CITY OF ALBUQUERQUE

August 10, 2023

Re: The George/ 34 Unit Apartment Building 1701 Central Ave. NW Traffic Circulation Layout Architect's Stamp 08-04-23 (J13-D220)

TRAFFIC CONTROL LAYOUT PLAN

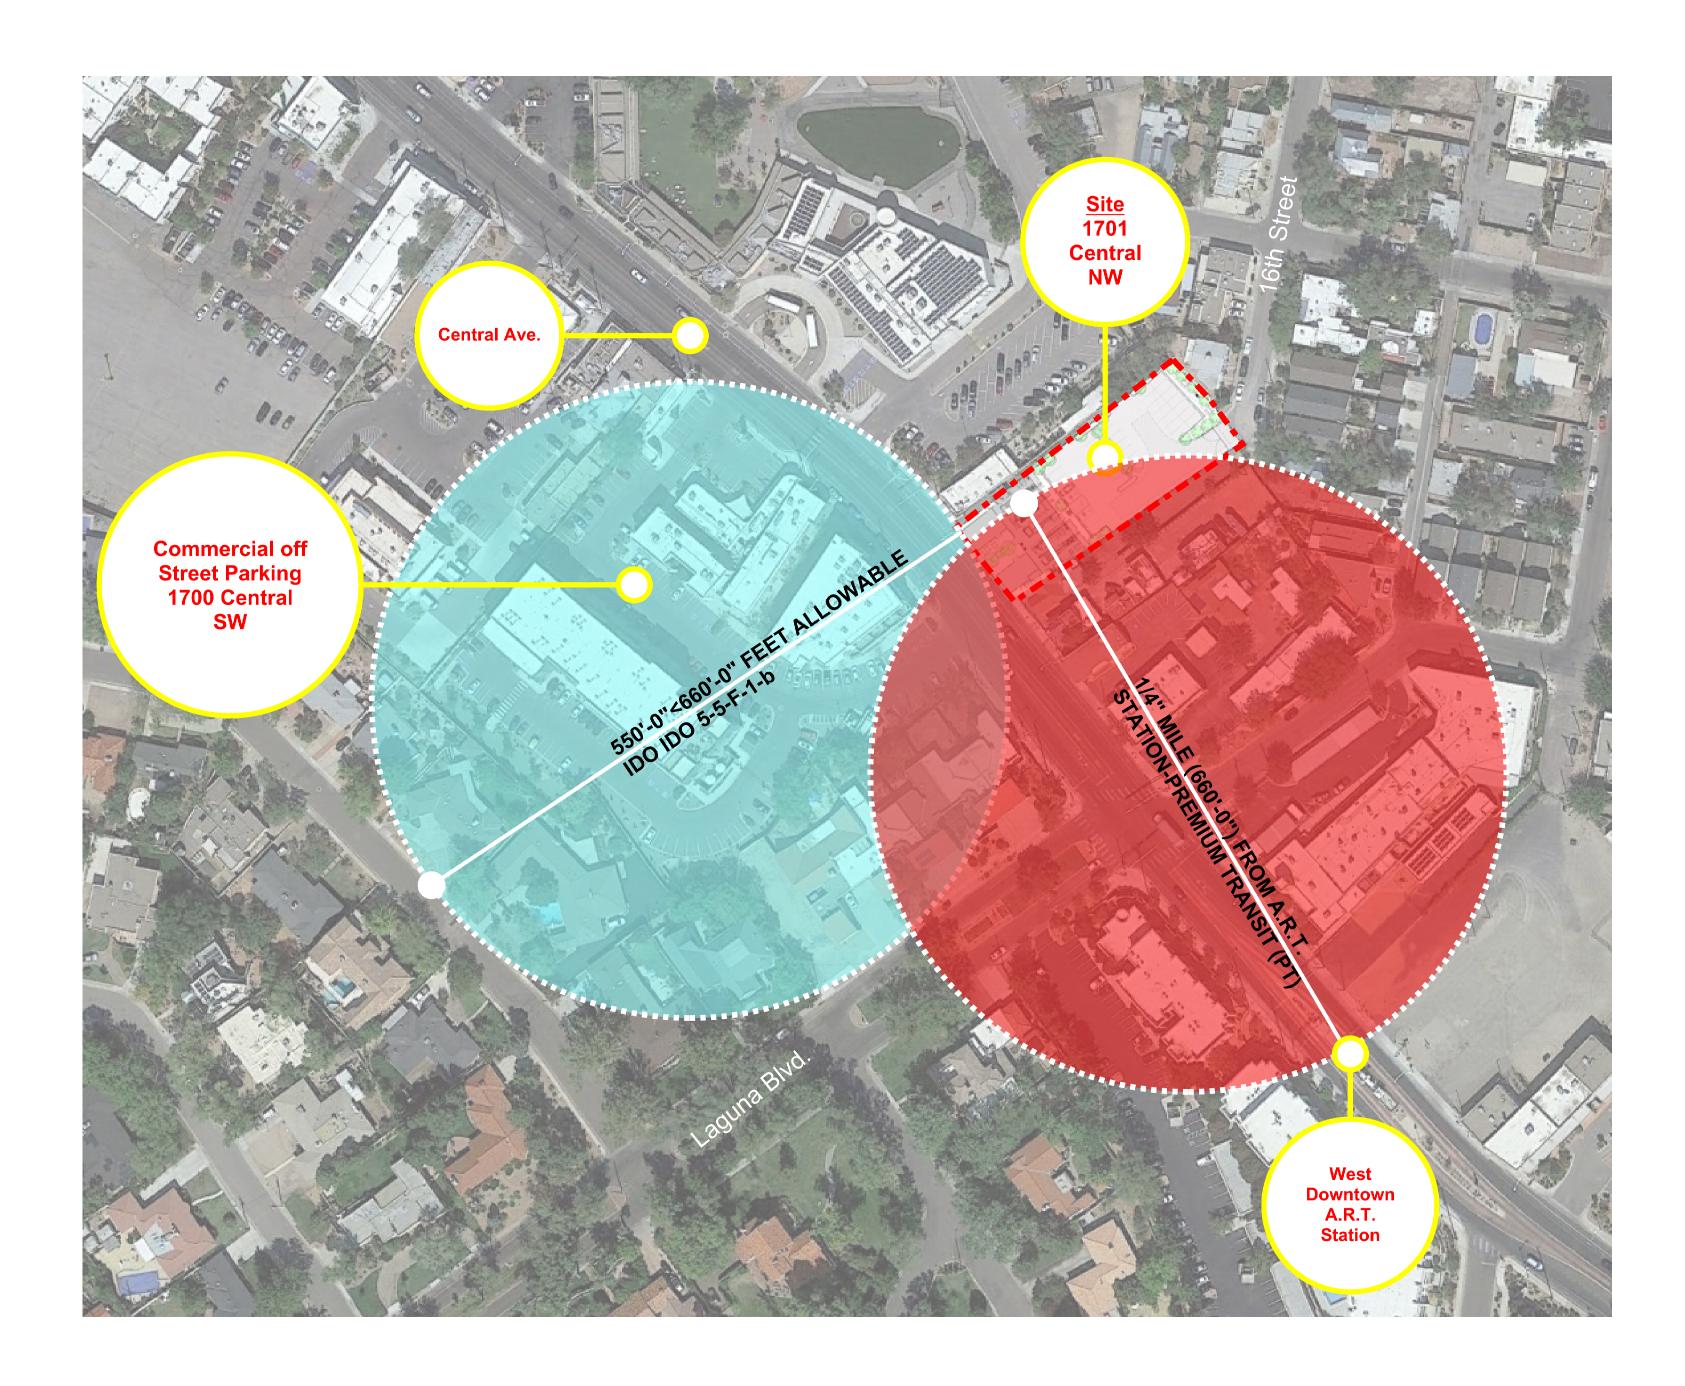
- 1. Please show on the site plan the north direction to determine the orientation of the site.
- 2. Identify all existing access easements and rights of way width dimensions.
- 3. Identify the right of way width, medians, curb cuts, and street widths on Central Ave. and 16th St.
- 4. Shared parking agreement must approve and signed by director Alan Varela and city authorized notary.
- 5. Site access must be built per City standard.
- 6. Keynote 18: please reference COA STD DWG 2430. And it appears there is a water meter on the public sidewalk by the construction area off Central. Please contact Water Authority for a permit.

- 7. Please define keynote 29.
- 8. Refuse vehicle maneuvering shall be contained on-site. The refuse vehicle shall not back into the public right of way.; provide a copy of refuse approval.
- 9. Show the clear sight triangle and add the following note to the plan: "Landscaping and signage will not interfere with clear sight requirements. Therefore, signs, walls, trees, and shrubbery between 3 and 8 feet tall (as measured from the gutter pan) will not be acceptable in the clear sight triangle.
- 10. Please specify the City Standard Drawing Number when applicable.
- 11. Add a note stating "All broken or cracked sidewalk must be replaced with sidewalk and curb & gutter." A build note must be provided referring to the appropriate City Standard drawing.
 - 12. Please provide a letter of response for all comments given.
